**CITY OF PORTLAND, MAINE
DEVELOPMENT REVIEW APPLICATION
PLANNING DEPARTMENT PROCESSING FORM
Planning Copy**

Amendment to Plan - University Park

At the request of Jay Reynolds, Development Review Coordinator, Land Use Consultants is submitting an application amendment and request for minor changes to the approved Grading Plan for Yale Court (Sheet C-9), on behalf of the Applicant, Yale Court Limited Partners. This request is a result of minor grading changes around the buildings required to clarify grading directly around each unit and coordinate the typical grading indicated on structural foundation details with the approved Grading Plan. Initially, construction sketches were issued to the contractor as a field directive for revisions at each unit. However, Mr. Reynolds has indicated that these revisions must be reviewed by the City as an amendment to the approved Site Plan. No changes were made which would alter or revise drainage, drainage patterns, drainage calculations, stormwater management, water quality treatment, impervious areas or other permit compliance issues. It is our understanding these changes may be considered diminutive in scope and can be reviewed at the admin

TITLE:
REVISED PARKING LAYOUT

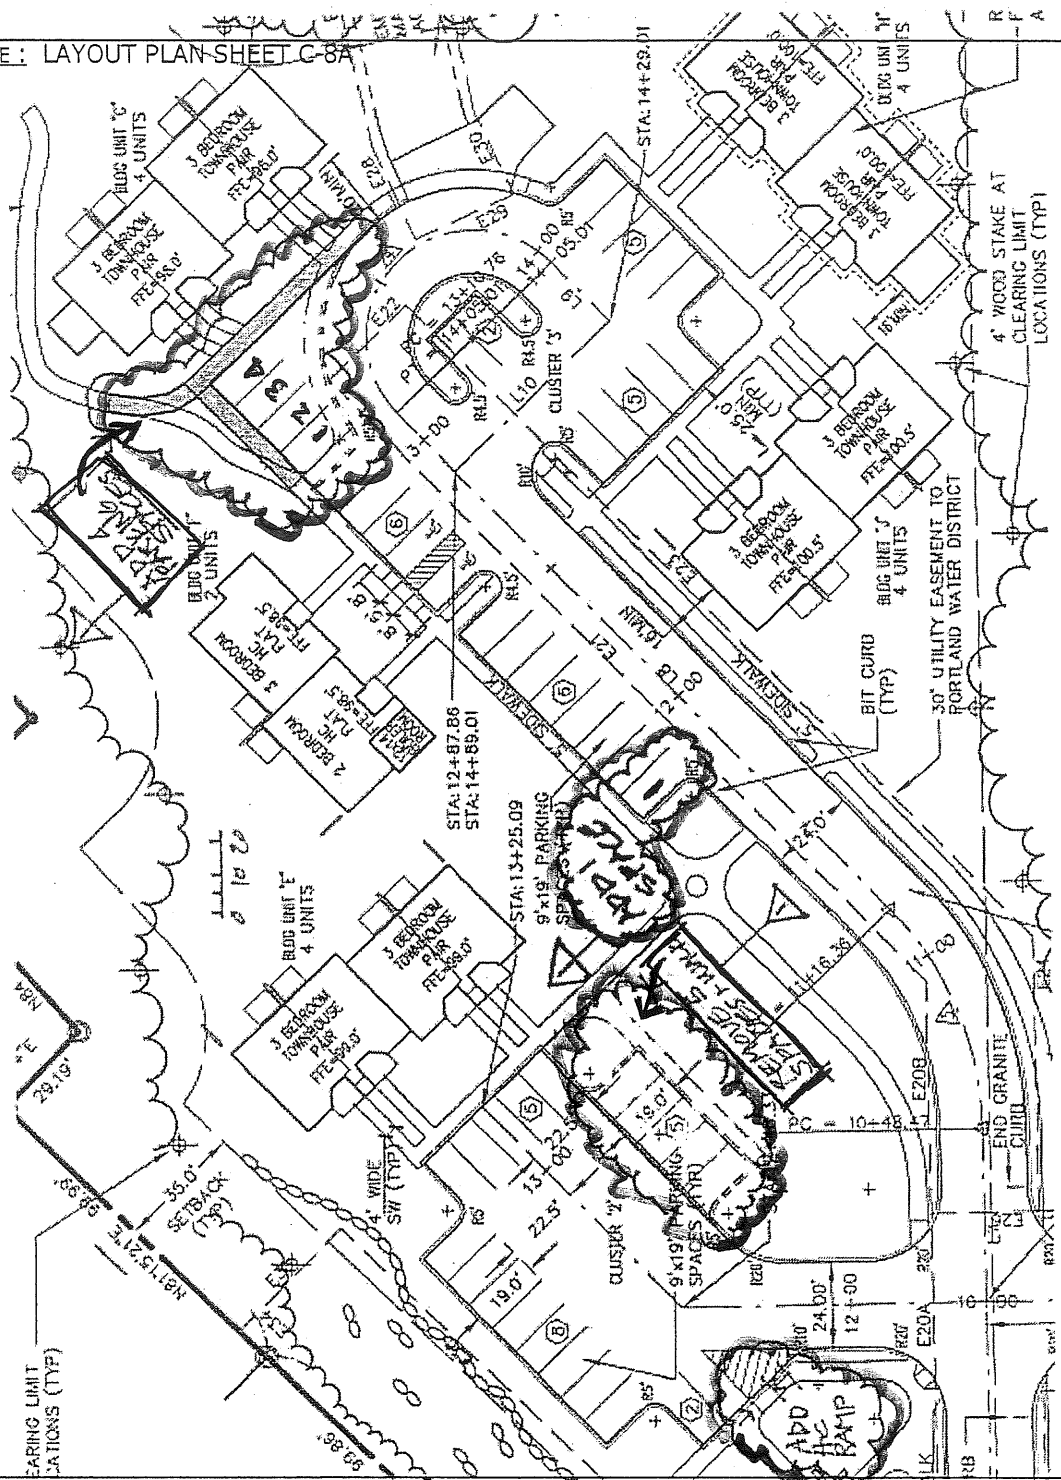
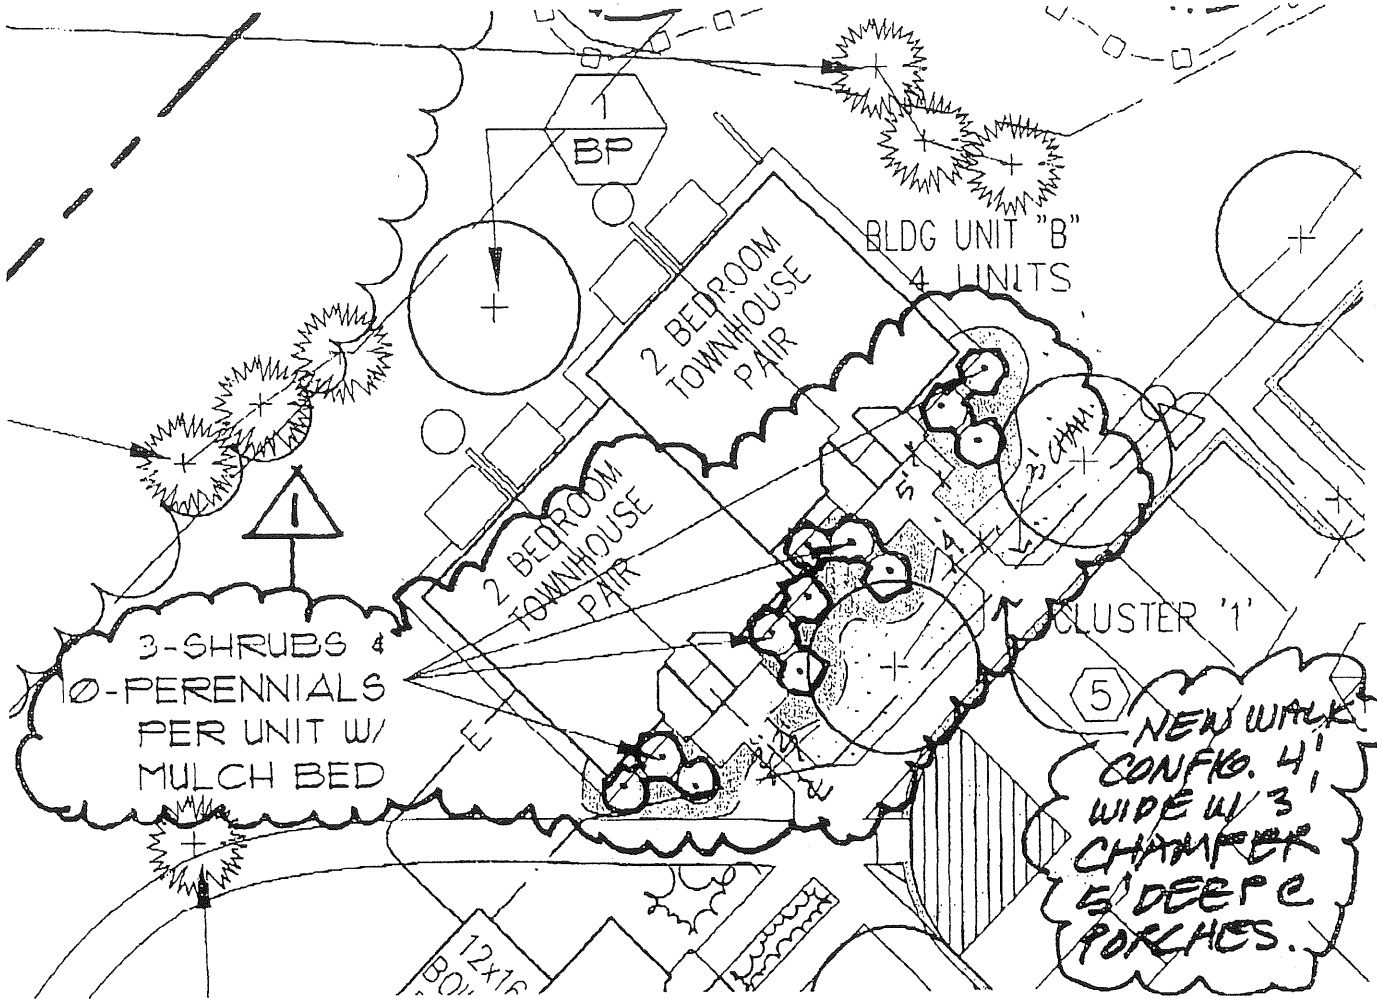
1. Remove and relocate five parking stalls as illustrated on attached *Sketch LSK-1-Revised Parking Layout*. This change was discussed with the City planning staff prior to bid and was issued to bidders in the sketch plan format.
